REQUEST FOR TENDER No. 22-003

Chase River Pump Station Upgrades

Addendum 3

Issued: February 15, 2022

A50959

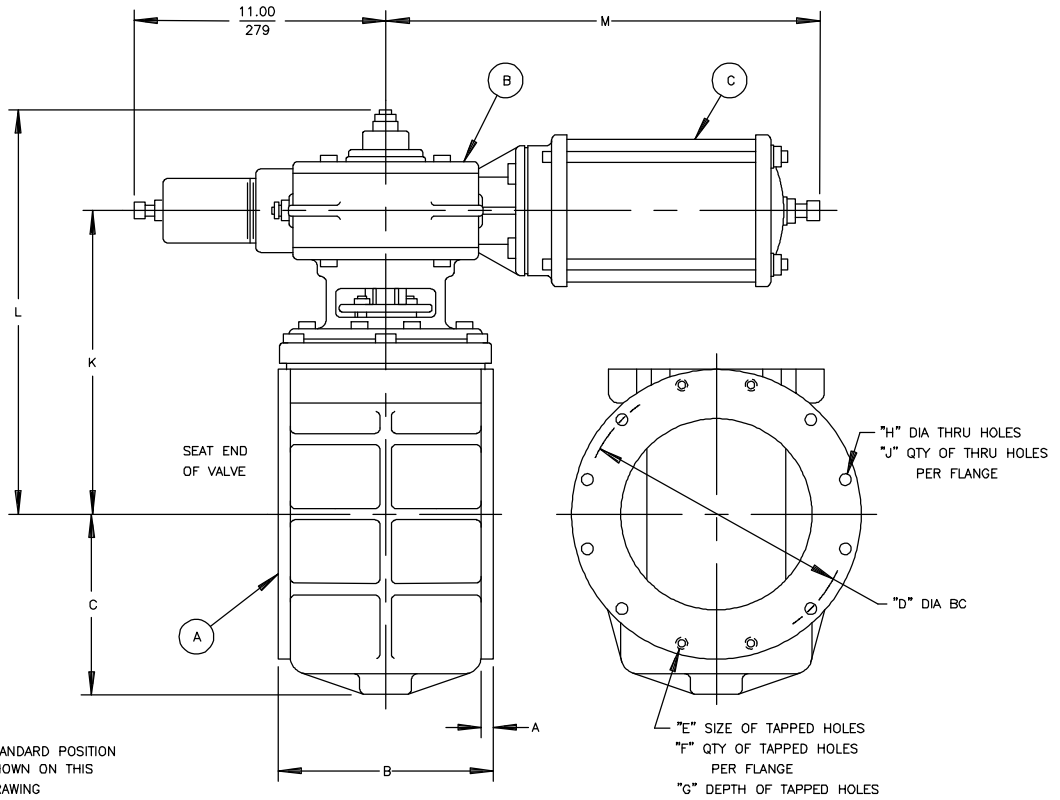
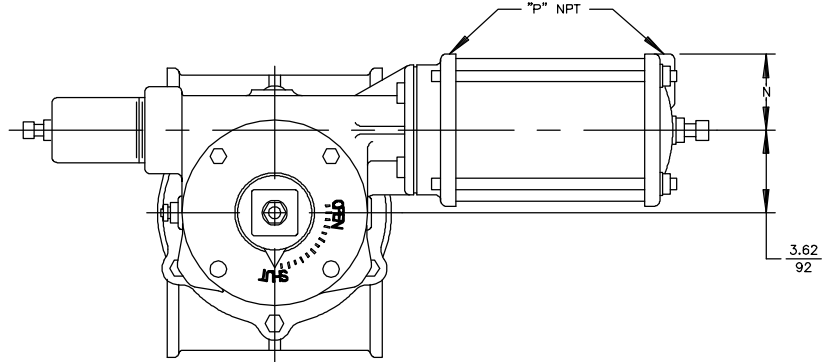
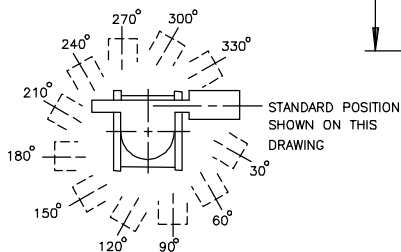
7. **Question:** Dezurik plug valves supplied by the RDN are pneumatic and require compressed air system yet no detailed drawings depict any of the lay out of the piping and tie-ins for the valves/compressor. Can you provide if this is required to be installed by the contractor?

1. **Addition to the Drawings** – See attached DeZurik control valve and actuator drawing A50959 Revision A (RDN supply).
2. **Addition to the Drawings** – See attached DeZurik detailed control valve actuator drawing J34123 Revision B (RDN supply).
3. **Revised Project Summary Schedule** – See attached revised project overview schedule with revised target date for Notice of Intent to Award, adjusted shutdown work start date and increased shutdown time allowance.
4. **Note** – RDN is aware that the City of Nanaimo has used Aureus and Canadian Dewatering for bypass pumping operations on previous jobs. Contractors are encouraged to contact the City for more information, if needed.

Answer: *All of the existing compressed air supply lines are intended to be reused. Please refer to DeZurik shop drawings attached, detailing the scope of controls supply. Contractors may remove existing air supply lines, for construction convenience and/or to avoid damage, and field reinstate them after demolition and reinstallation of the large bore piping.*
